**Solid Sodium Cyanide Plant Kwinana**

**Du Pont (Australia) Pty Ltd**

**Report and Recommendations  
of the  
Environmental Protection Authority**

Environmental Protection Authority  
Perth, Western Australia  
Bulletin 425 January 1990

Figure 2: Simplified process flow diagram.  
Source : PER

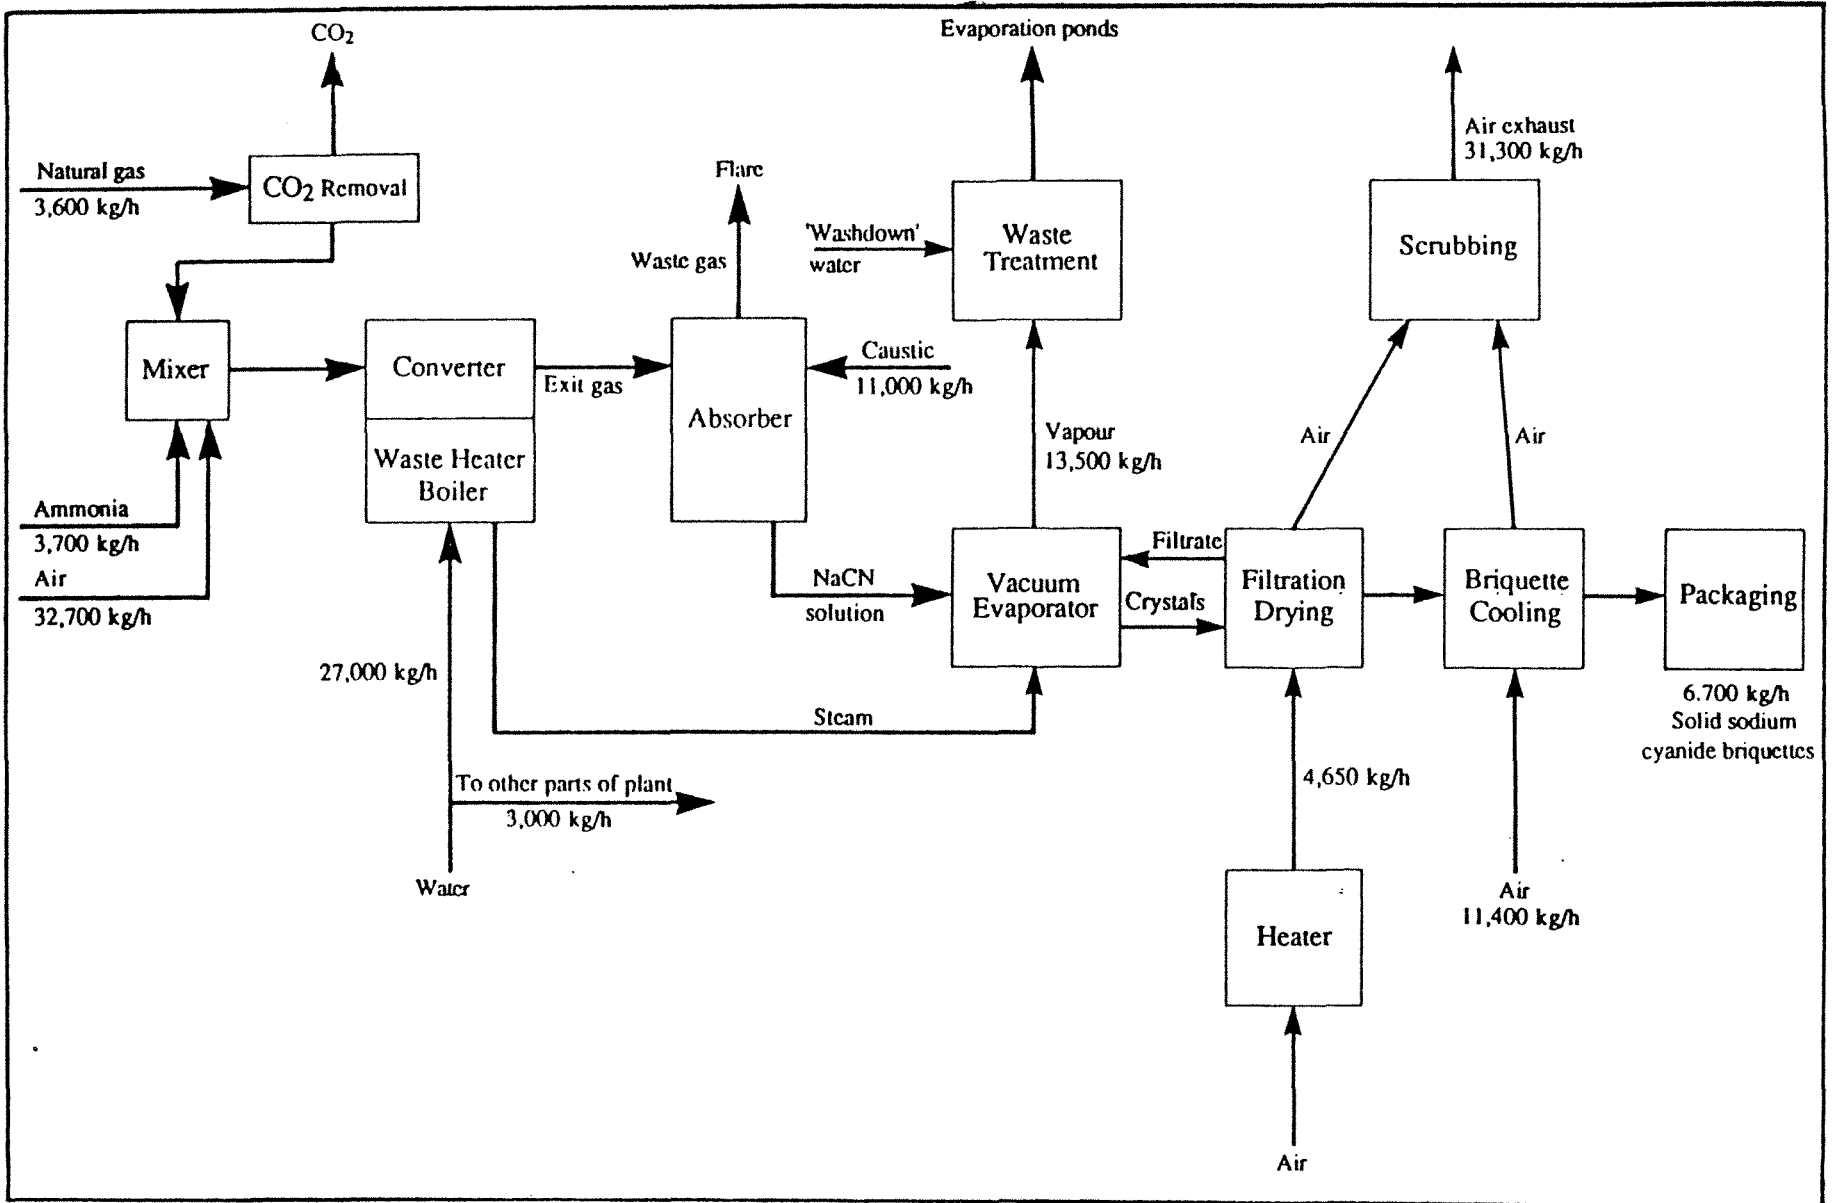
QUESTION 46 Fig 4.1 shows 31,300 kg/h of air being discharged from the scrubber, yet section 4.6 refers to 22,675 kg/h. Which figure is correct and given the stated efficiencies of sodium cyanide and hydrogen cyanide removal (99% and 98% respectively) how much sodium cyanide and hydrogen cyanide will be emitted?

Figure 4: Individual risk contours

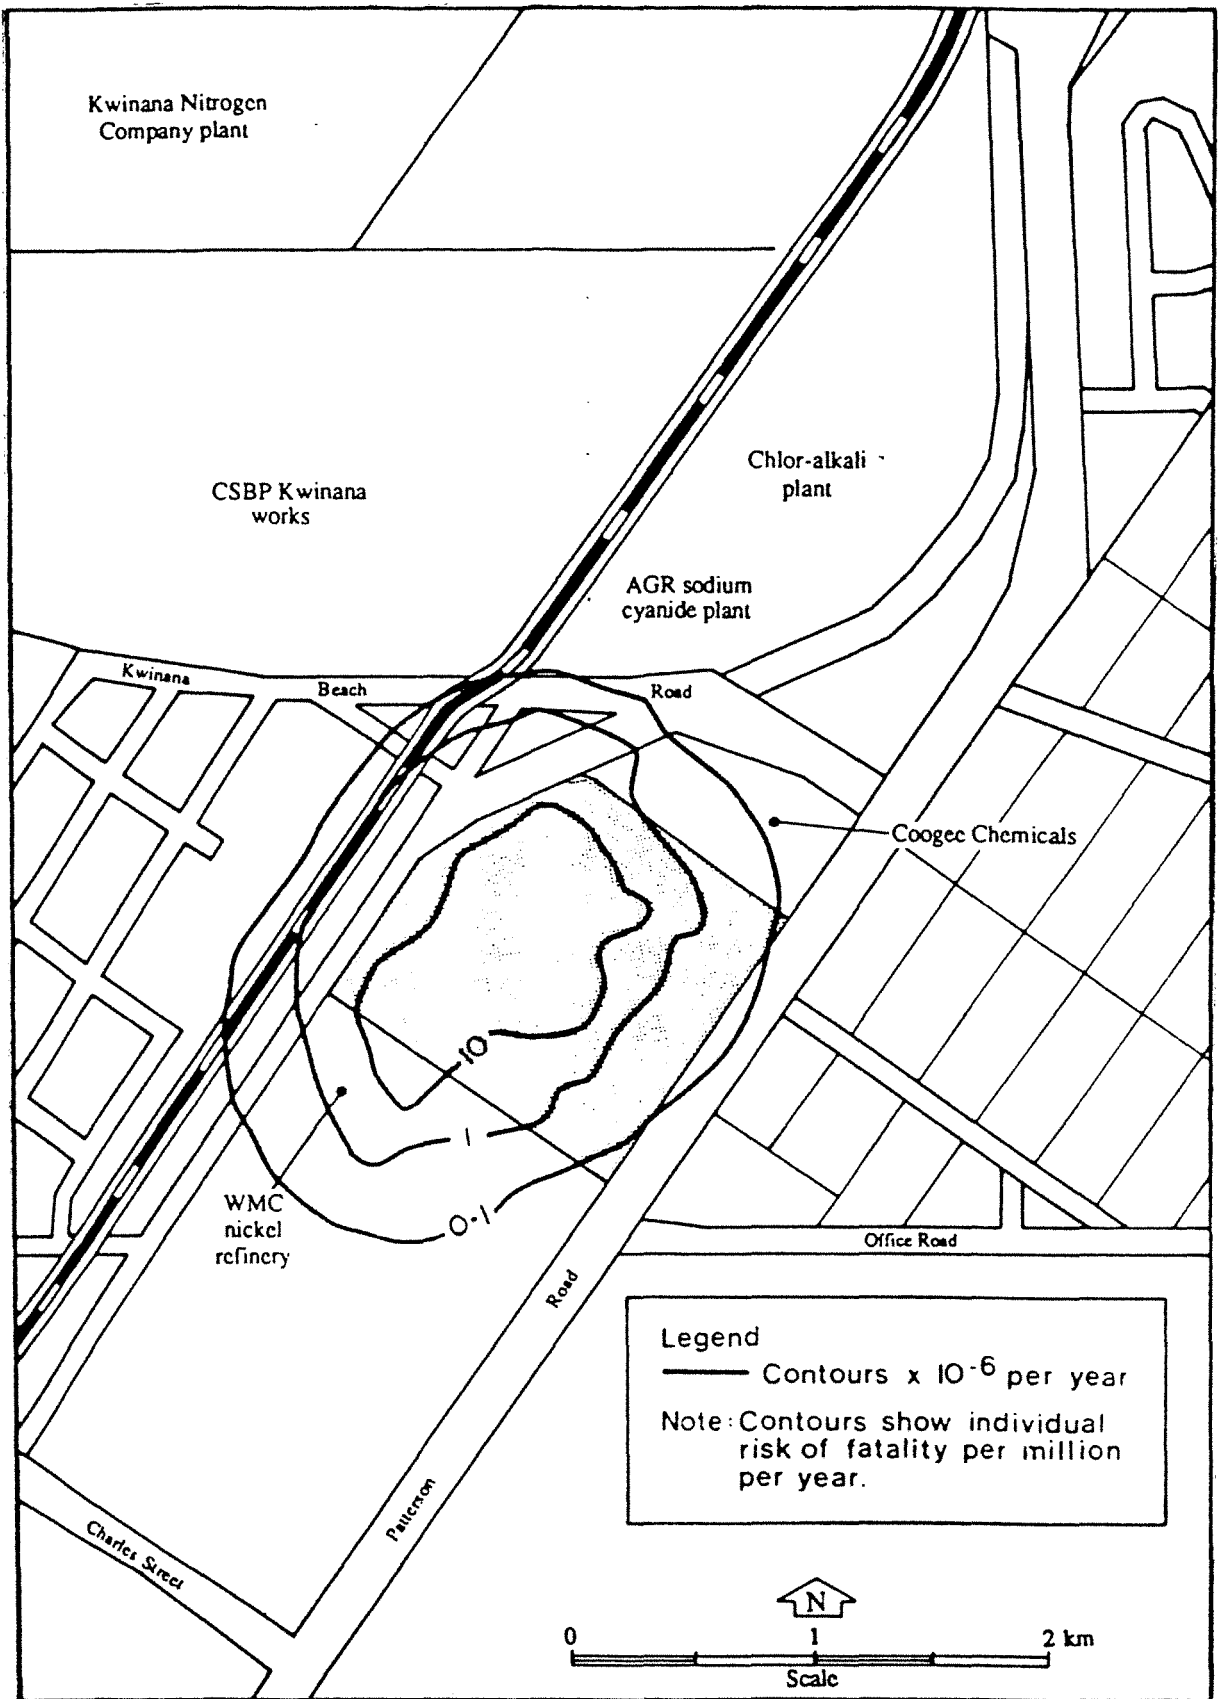
The results of the analysis of all possible incidents were added together to give the total off-site risk from the plant, in terms of the likely number of deaths per million years. Figure 1.1 of the PRA presents the overall result. This is included in this report as Figure 4.

The results show that risk levels reduce to less than one-death-in-ten-million-years within the immediate vicinity of the plant boundary.

Figure 5: Kwinana cumulative individual risk levels - including proposed plant

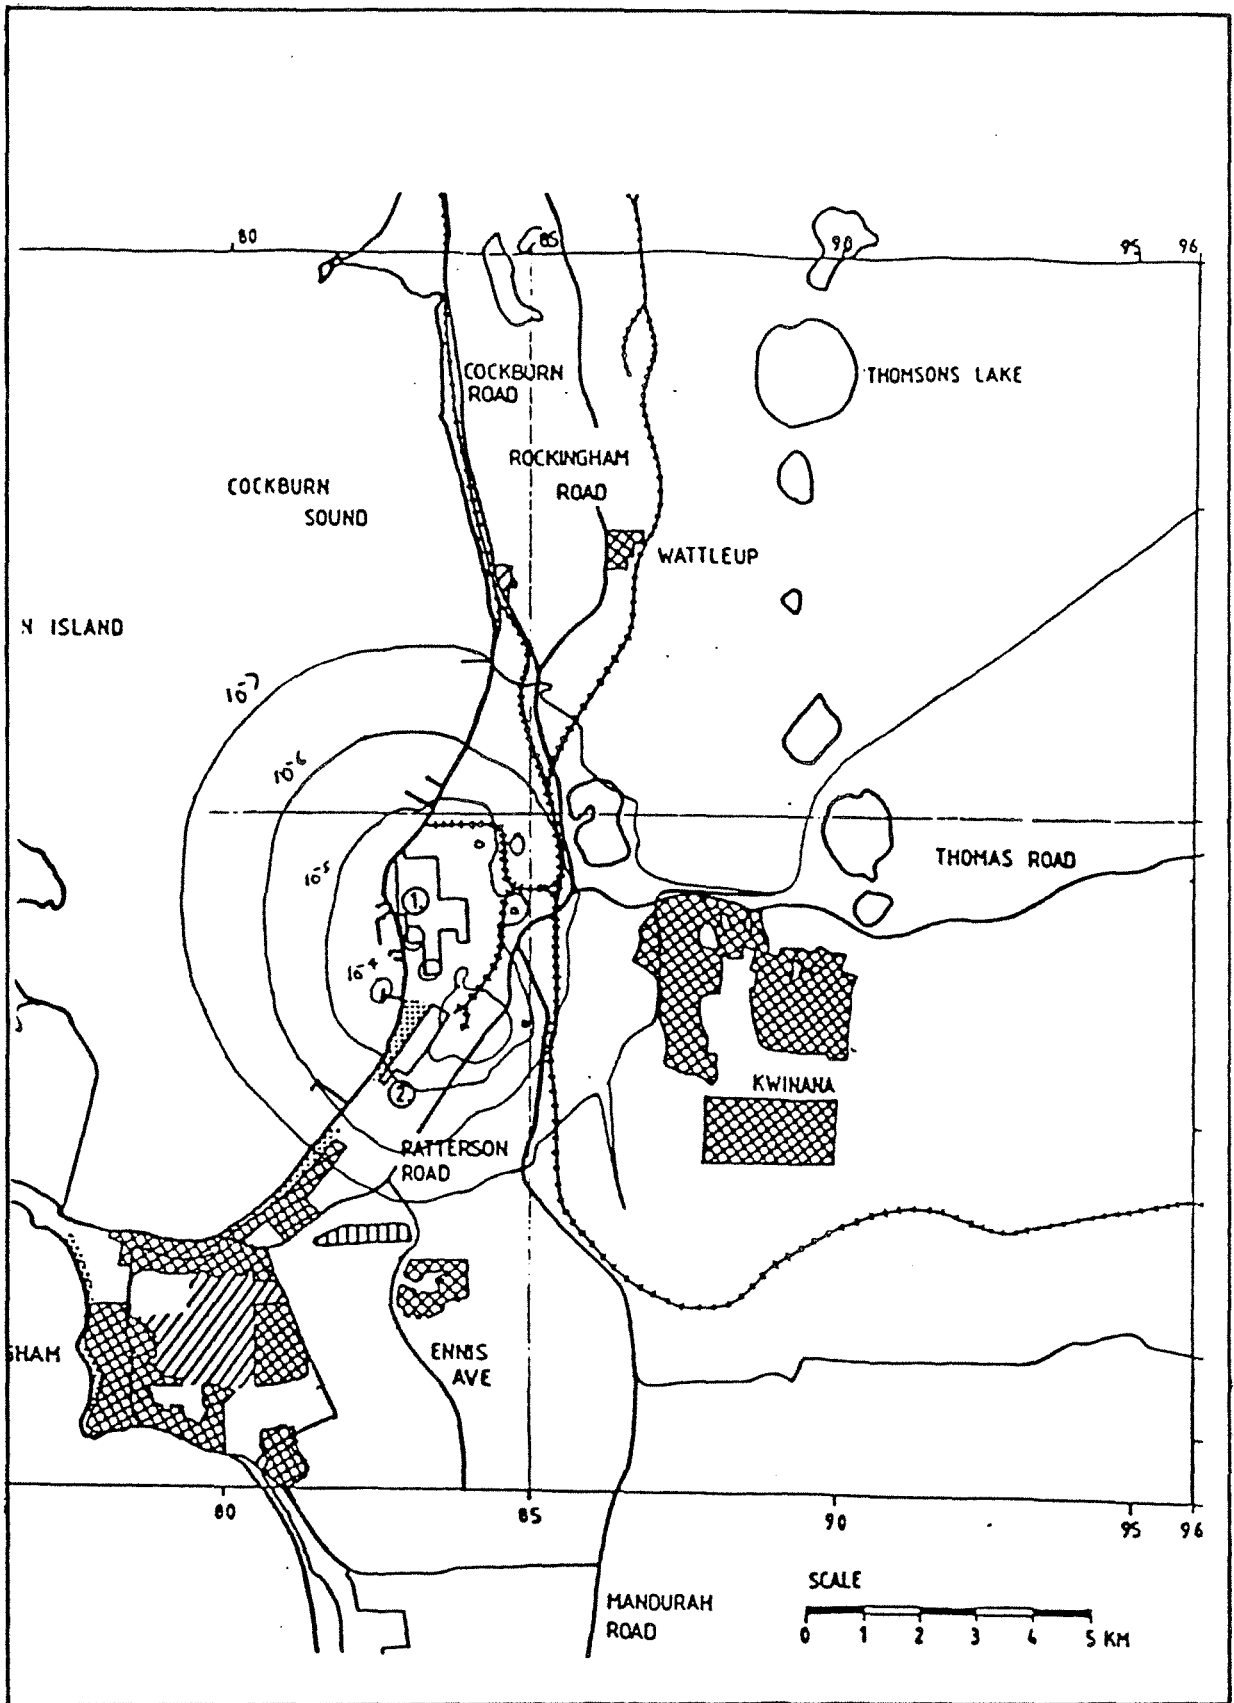
The cumulative risk contours, reproduced in this report as Figure 5, show that the one-in-a-million level extends to the CBH Jetty in the south, the Thomas Road-Rockingham Road intersection in the east, and the SECWA Power Station in the north. By overlaying the base case (Figure 1 from the Technica report) with the cumulative risk contours including the proposed plant, it can be seen that the proposed plant has no influence on the one-in-a-million contour. The criterion is satisfied, well within the non-residential areas.

**The Environmental Protection Authority concludes that, subject to the Recommendation below, the proposal does not impose an unacceptable level of risk on residential areas.**
